# UNITED STATES PATENT AND TRADEMARK OFFICE

10/667,954

## Office Action Summary

BERTI, ENZO

Robertson (USPN D468106, figure 1)

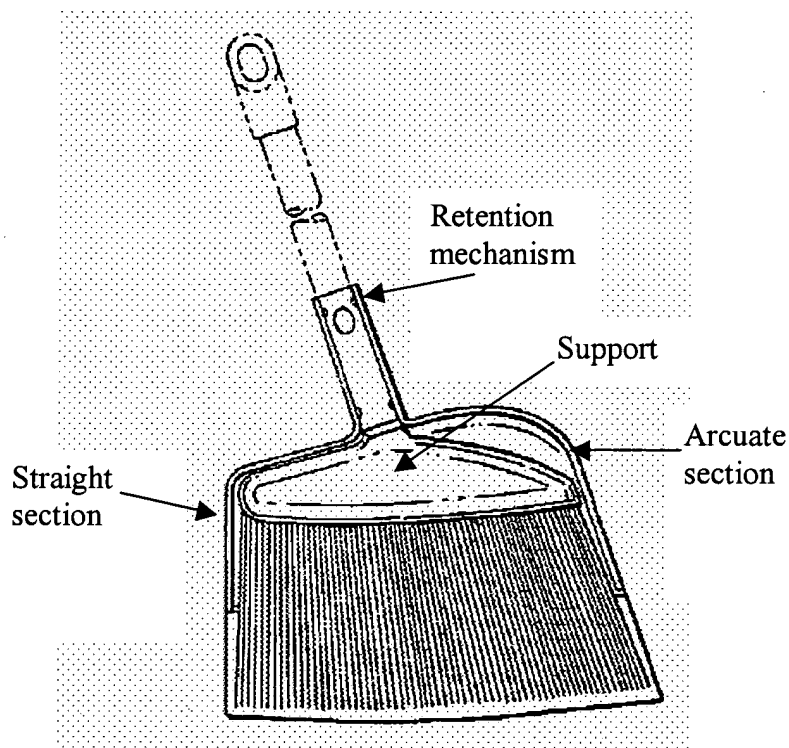
the handle (claim 1). The support has a top side attached to the handle and bottom side with bristles projecting from the bottom side (claim 1). The bristles define a sweeping plane and the broom handle axis and the sweeping plane form an obtuse angle (claim 1). The broom handle is engageable with the broom handle cavity on the dustpan (claim 1). The dustpan handle projects from an end of the arcuate section opposite the leading edge and at a position intermediate the ends of the arcuate section (claims 6, 7).

Robertson teaches all the essential elements of the claimed invention however, the reference fails to teach that the rib defines a continuous arcuate section extending from one side of the leading edge to the handle (claim 1). At the time the invention was made, it would have been obvious to a person of ordinary skill in the art to use a continuous arcuate section because Applicant has not disclosed that a continuous arcuate section provides an advantage, is used for a particular purpose, or solves a stated problem. One of ordinary skill in the art, furthermore, would have expected Applicant's invention to perform equally well with the arcuate section as taught by Robertson or the claimed continuous arcuate section because both arcuate sections perform the same functions of facilitating movement of dust or trash along its periphery by action of the broom bristles and funneling trash equally well. Therefore, it would have been obvious to one of ordinary skill in the art to modify Robertson to obtain the invention as specified in claim 1.

Robertson teaches all the essential elements of the claimed invention however, the reference fails to teach an angle of 50-75 degrees between the leading edge and the straight edge (claim 2). At the time the invention was made, it would have been obvious to a person of ordinary skill in the art to provide an angle of 50-75 degrees between the leading edge and the

straight edge because Applicant has not disclosed that an angle of 50-75 degrees provides an advantage, is used for a particular purpose, or solves a stated problem. One of ordinary skill in the art, furthermore, would have expected Applicant's invention to perform equally well with either the angle as taught by Robertson or the claimed 50-75 degree angle because both configurations allow for proper collection and disposal of waste.
